Application for Works Approval

Works Approval Number	W6972/2024/1
Applicant	Greatland Pty Ltd
ACN	108 498 997
File number	INS-0002947
Premises	Havieron Project Mining Tenement M45/1287 East Pilbara, WA, 6762 As defined by Schedule 1 of the works approval
Date of report	20 May 2025
Decision	Works approval granted

Appendix 1: Summary of applicant's comments on draft decision report and works approval – includes proposed revisions

Figure 5. Hypersaline Evaporation ponds gravity distribution layout

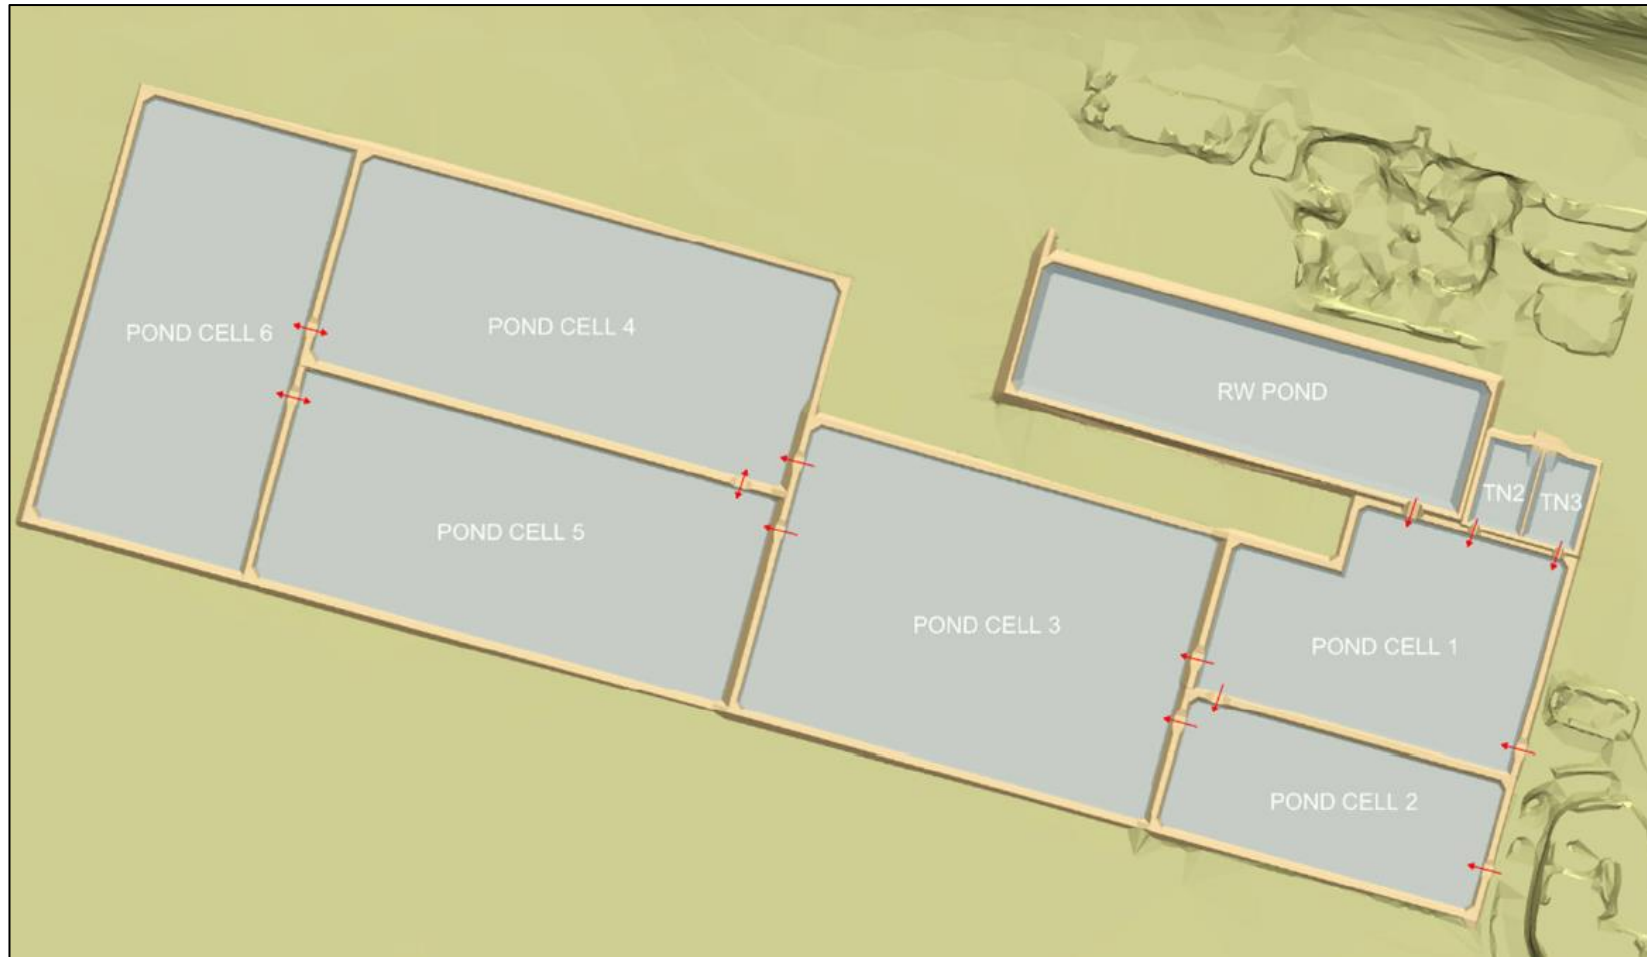
<p>Condition 13 Table 4</p> <p>Decision Report – Section 2.2.2</p>	<p>The condition requires the cumulative discharge volume to be recorded. However, under the planned construction specifications the flow to the proposed ponds will be discharge through internal pipelines operating under gravity or over weirs. Given these specifications, Greatland Pty Ltd will be unable to record the flow going into each pond.</p>	<p>These construction specifications represent a departure from those proposed under the original application. Recording of cumulative flow into the proposed ponds assists the applicant in maintaining control over the discharge. It also allows the applicant to quickly identify whether malfunctions or breaches are occurring, potentially preventing any unforeseen environmental damage from overtopping.</p> <p>Nonetheless, given that cumulative inflow will be monitored at ponds 1-3 in accordance with the licence and that daily visual monitoring of the new ponds will also occur, the department finds that sufficient controls are in place to prevent overtopping. Condition 13 requiring cumulative discharge volume to be monitored has been removed.</p> <p>The risk assessment Table (Table 5) of this decision report has been amended to reflect the change in the proposed controls. No additional controls were included as a result of the above revision.</p>

Figure 6. Location and reference of existing and proposed monitoring bores (Note: only bore HAEPMB05 is now proposed)

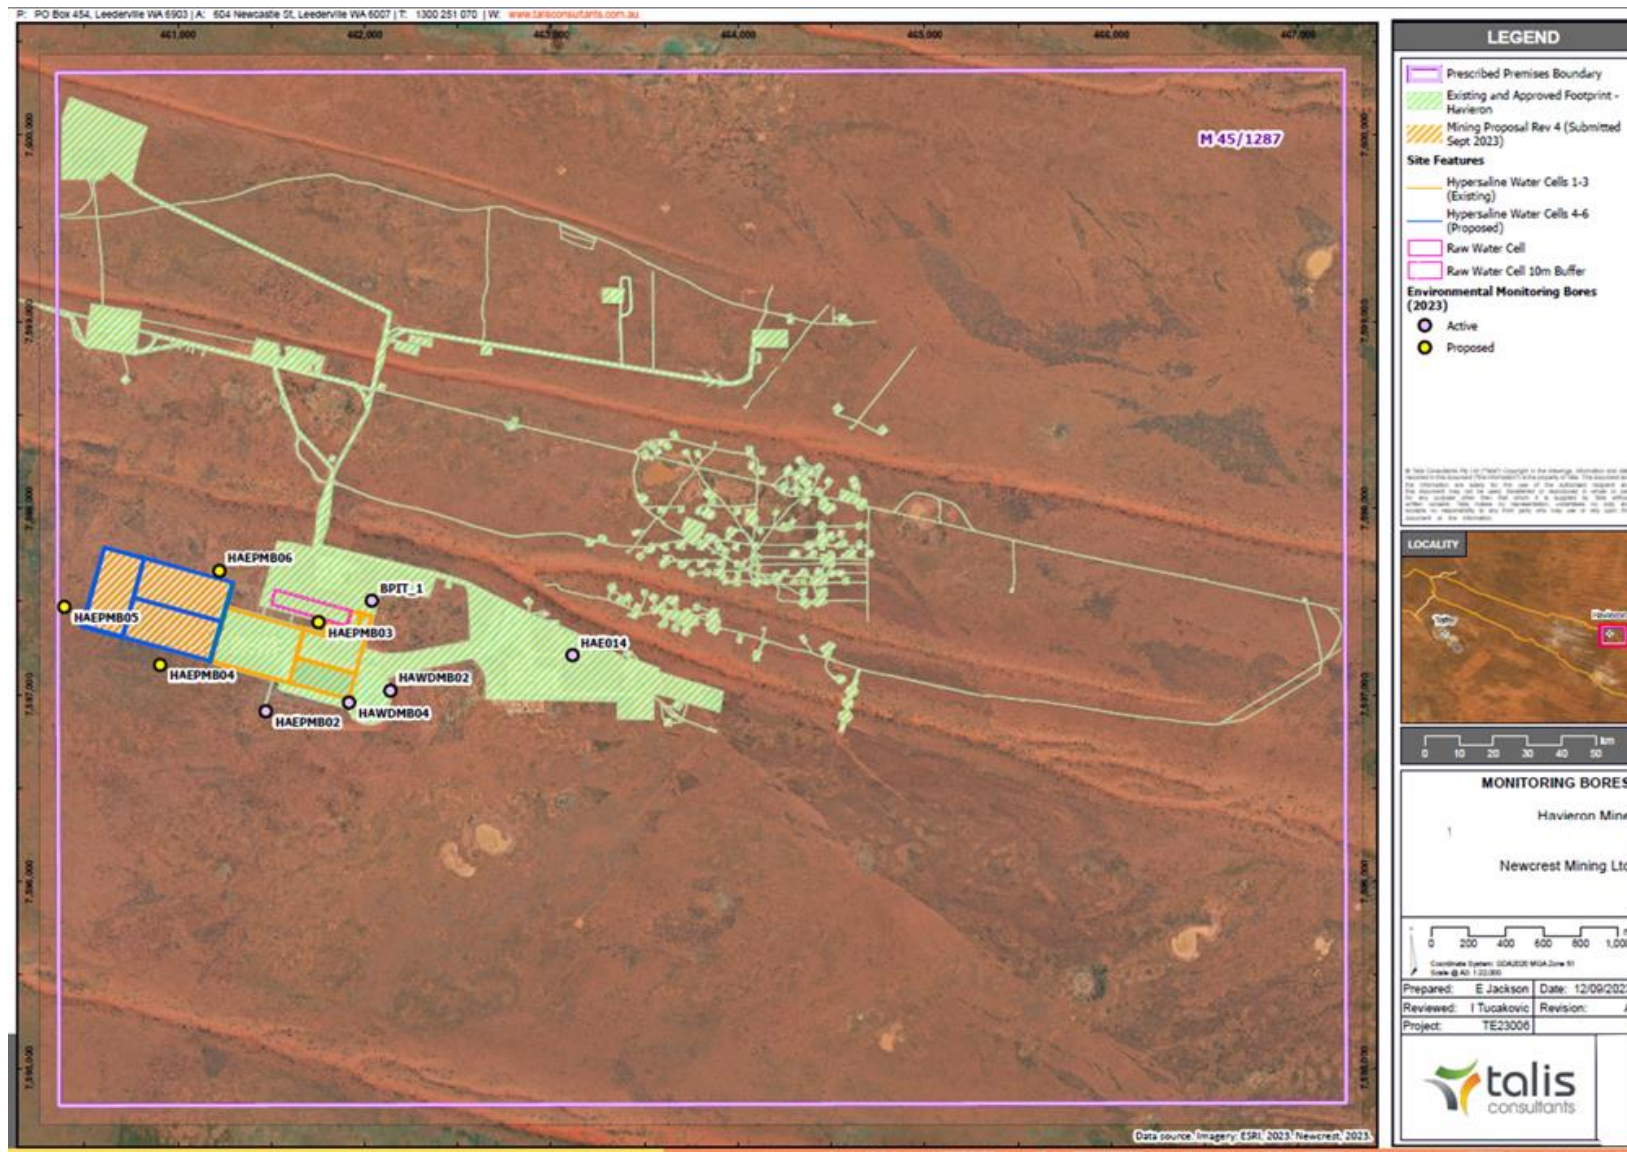
Condition 3, Condition 16 Decision report – Section 2.2.4	Greatland Pty Ltd has conducted a review of the groundwater monitoring network and has established that one groundwater monitoring bore to the west of the proposed process ponds will be sufficient to detect any seepage. This additional bore and the existing network will provide sufficient coverage to the north, south, east and west of the ponds. Additionally,	<p>The likelihood of seepage was discussed in the Risk Assessment Table (Table 5).</p> <p>The department agrees that seepage through the base and walls of the process ponds is unlikely during time limited operations, partly due to the</p>

Condition	Summary of applicant's comment	Department's response
	<p>as the ponds will be lined, seepage is unlikely to occur. It should also be noted that condition 8 of the licence for the premises (L9455/2024/1) requires a monthly water balance. The water balance will provide an additional tool to identify excessive losses beyond those caused by evaporation.</p>	<p>duration of discharge and partly due to the lining that, if appropriately fitted, will prevent most of the seepage.</p> <p>The risk assessment table has been updated to reflect that only one additional bore will be constructed (HAEP05). Similarly, condition 3 and condition 16 of the works approval have been revised. Figure 3 of Schedule 1 has also been replaced to show the layout of the groundwater bores at the premises.</p> <p>It is noted that the location of HAHY037 (not within the scope of this works approval) appears to be in a different location to that shown on the licence. As discussed below, if the applicant has departed from any licence conditions, an amendment of these conditions should be sought.</p>
